**GIANT**  
REFINING COMPANY

January 17, 2005

Re: Giant Bloomfield Refinery – NMED Conditional Approval of North Boundary  
Barrier Voluntary Corrective Measures Plan  
RCRA Permit No. NMD 089416416  
HWB-GRCB-04-005

**ATTACHMENT B**  
**Typical Piezometer Log**

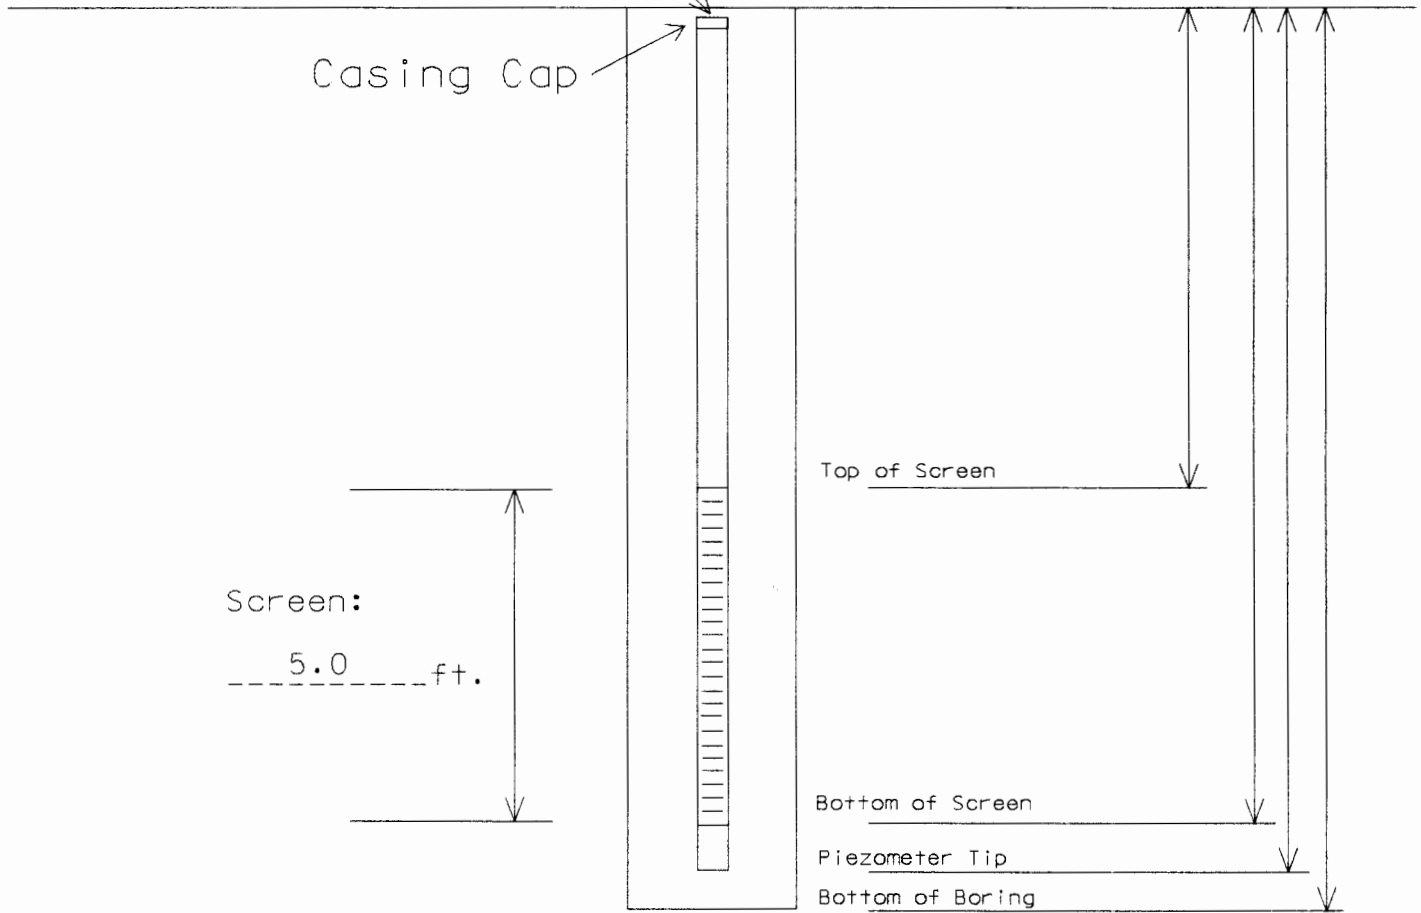
11. A typical log for the piezometers installed in the soil borings along the north property boundary is contained in Attachment B. The depth to water (bgs) in each of the locations is stated in the upper left header of the logs contained in Appendix A of the CAP. It should be noted that many of the subject piezometers will be destroyed during construction of the barrier wall.
